COMMUNITY DEVELOPMENT DEPARTMENT REPORT

HEARING DATE: 6/10/2025

APPLICANT: Laren Bailey, DevCo

SUBJECT: H-2024-0068
Adero Mixed-Use Neighborhood MDA,
PP, RZ

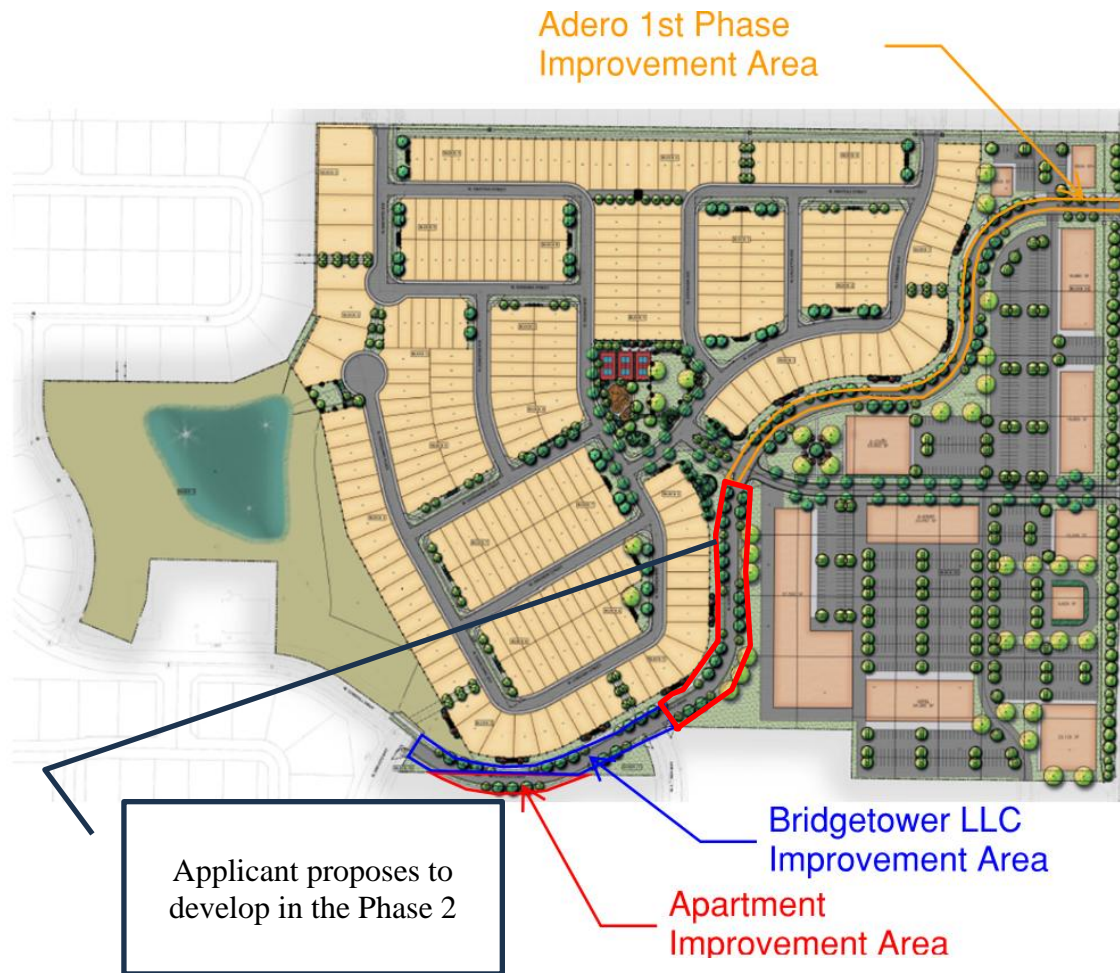
Collector Street: The collector street (W. Malta Drive/W. Gondola Drive) shall be developed as a three (3) lane collector street (either a 47-foot wide or 37-foot wide street section) at its intersection with Ten Mile Road within the influence area of the intersection. West of the intersection, taper the roadway to 2 lanes as follows:

- Construct W. Malta Drive/W. Gondola Drive as a 36-foot wide residential collector street section with 2- travel lanes, on-street bike lanes, vertical curb, gutter, a minimum 8-foot wide landscape strip and 5-foot wide detached concrete sidewalk; or
- Construct W. Malta Drive/W. Gondola Drive as a 26-foot wide residential collector street section with 2- travel lanes, vertical curb, gutter, a minimum 8-foot wide landscape strip and a minimum 10-foot wide multi-use pathway on both sides of the roadway.
- The multi-use pathway will need to transition to on-street bike lanes at the intersection of W. Malta Drive/W. Gondola Drive and San Vito Way.

W. Malta Drive/W. Gondola Drive shall be constructed as a completed street (travel lanes, curb, gutter, sidewalk and landscaping). Staff is recommending these improvements be included with Phase one (1) of the development.

G. Commercial Access and Pedestrian Plan (date: 5/8/2025)

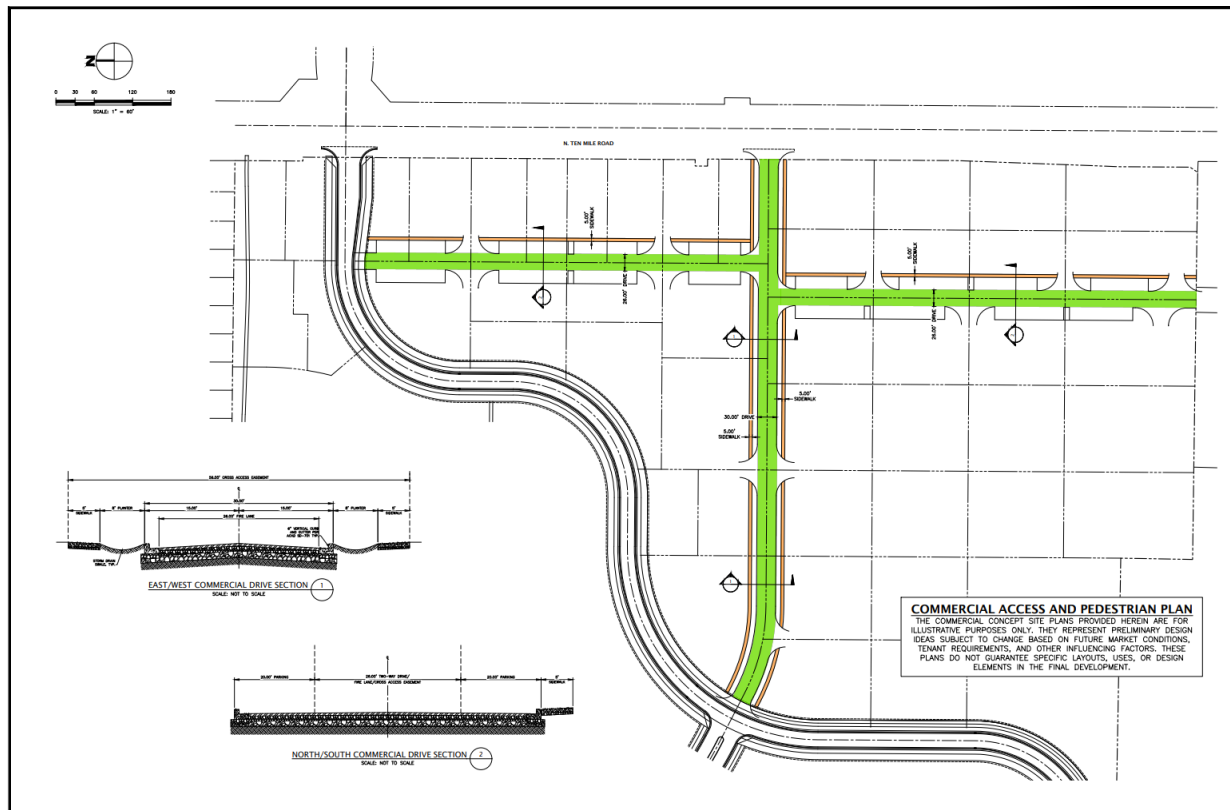
- q. Pedestrian circulation and cross access shall generally conform to the layouts depicted in the concept plans provided in Exhibits VI.G and VI.M.
